**Date:** June 13, 2023  
**To:** Jesse Leddick  
**Affiliation:** Massachusetts Division of Fisheries & Wildlife  
**From:** Katherine Brekka  
**Project:** YMCA-MV Field House Addition  
**Project No:** 1241

**Subject:** Emergency Access & Construction impact within Deed Restriction area

Title  
**DEED  
 RESTRICTION  
 AREA IMPACT**

**C101**

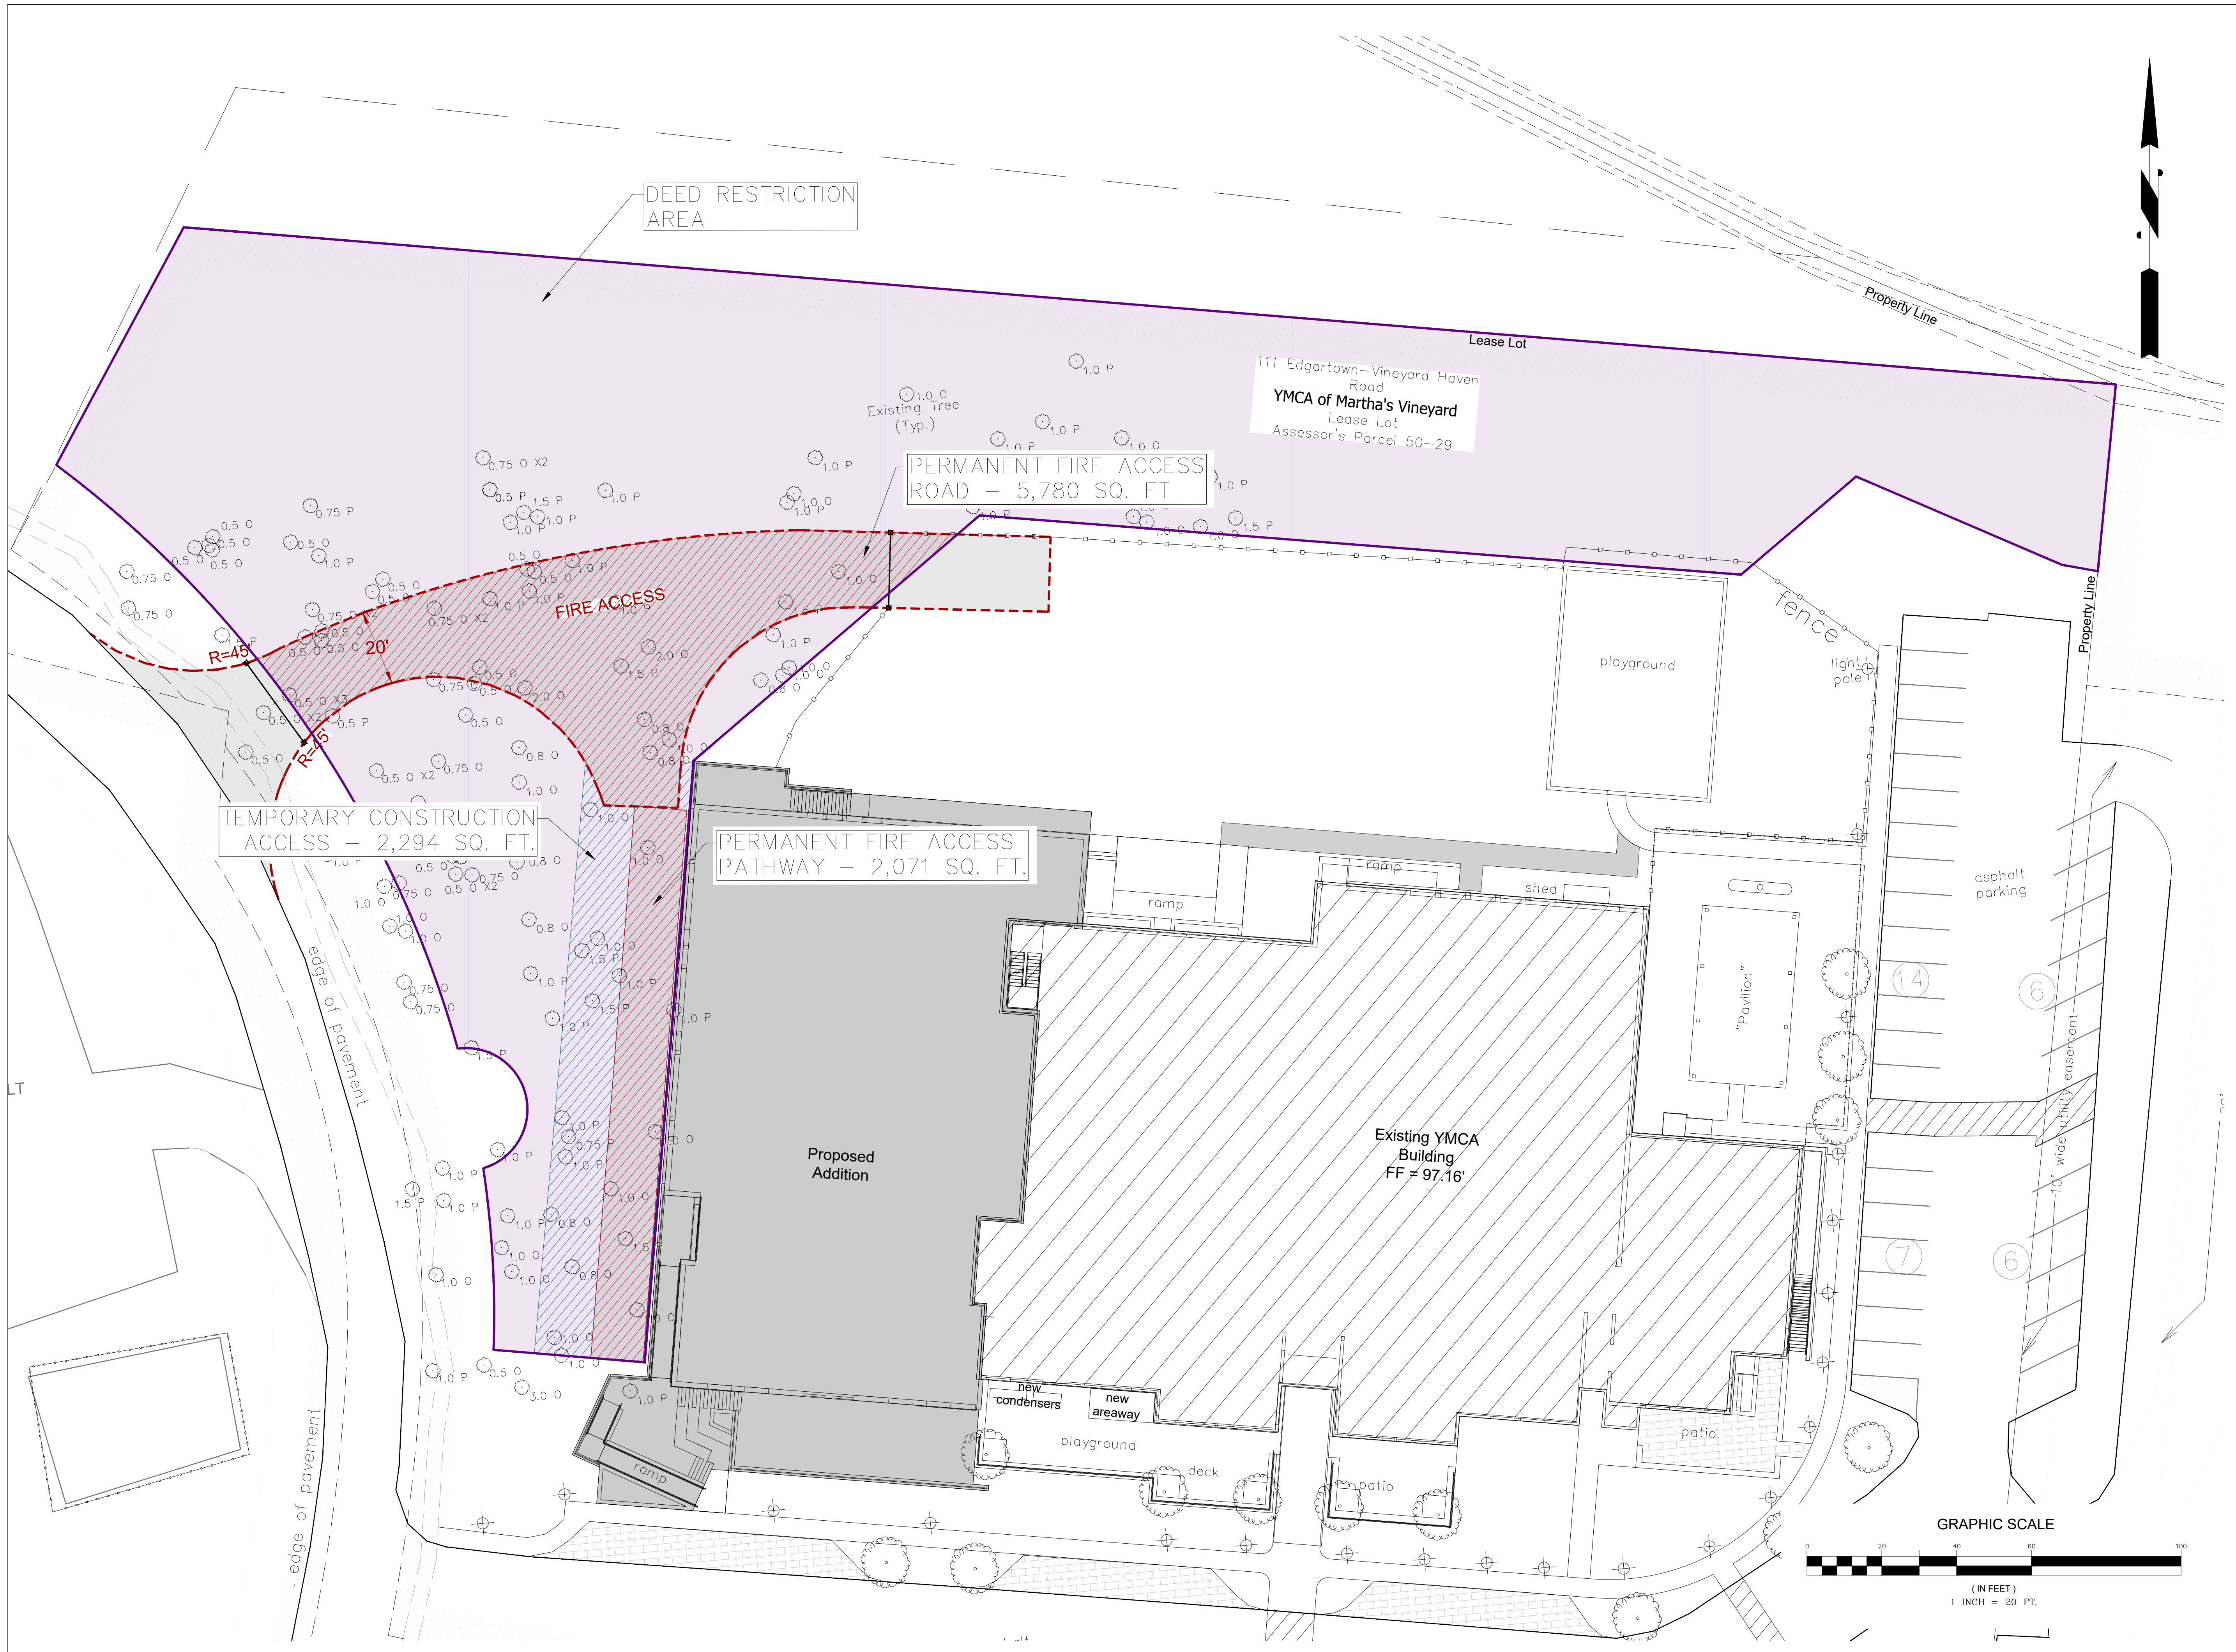
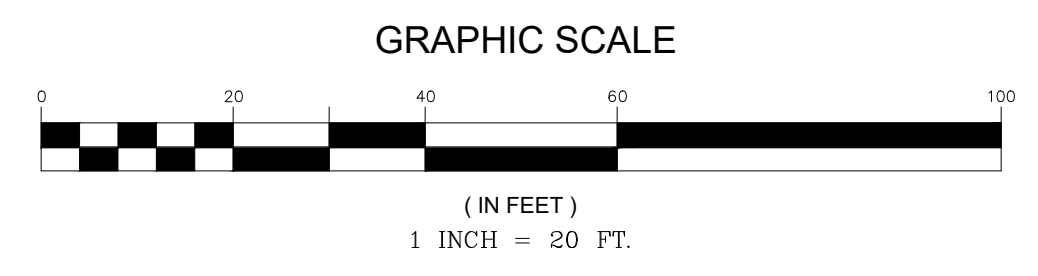
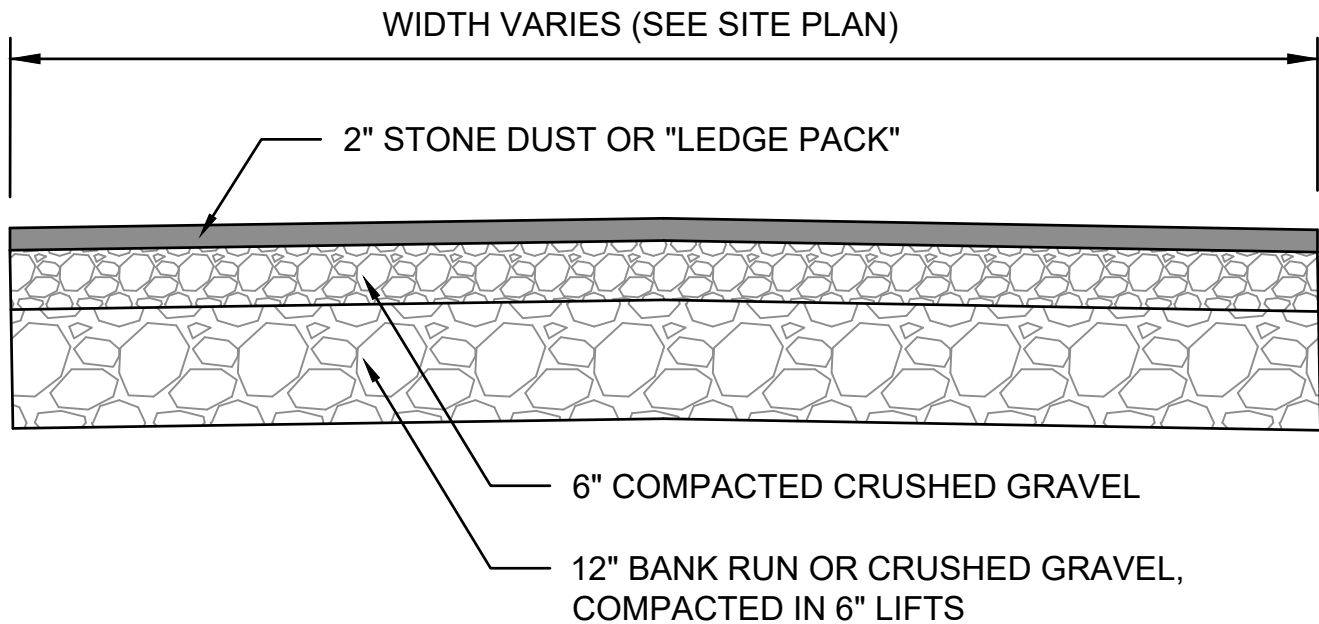
On behalf of the YMCA of Martha's Vineyard, we request your review and approval of the attached plan titled "C101 - DEED RESTRICTION AREA IMPACT". The "Declaration of Covenants Habitat & Open Space Conservation" documents the agreement made between the YMCA and the Martha's Vineyard Regional High School. While the proposed addition falls outside of the Deed Restriction area, we request approval to provide a temporary construction staging area and emergency vehicle access through the Deed Restriction zone. See attached plan, detail and landscape narrative describing the proposed scope of work & restoration.

The purpose of this letter is to request the approval for removal of existing native vegetation within the area protected by the "Declaration of Restriction". Our general contractor has indicated the need for a 30' staging area/construction zone along the west side of the proposed new addition. We have also received a two-part request from the Town of Oak Bluffs fire chief. Chief Wirtz has mandated that we 1 provide a permanent fire access lane and 2 a permanent fire access pathway. For public safety as shown on Plan C101 "Deed Restriction Area Impact" by RFS Engineering dated 6/13/2023. The permanent fire access lane represents approximately 5,780 SF of clearing and the construction zone in total is 4,365 SF. Once the building is completed the construction access will be reduced to the permanent fire access pathway of 2,071 SF. The installation of the construction zone & permanent fire access lane scope of work is as follows: The access areas will first be brushcut to "limit of work zone". Trees in access areas will be cut down. The brush will be chipped and stockpiled to be used for restoration. The tree stumps will be pulled and hauled away. The native vegetation (huckleberry) will be stripped and hauled away, the topsoil will be rototilled, stripped, and stockpiled, to be used for the construction access restoration.

The YMCA proposes to replant/restore the temporary construction access with native vegetation consisting of White Oak, Arrowwood (Viburnum), Winterberry, Shad, and woodchip groundcover.
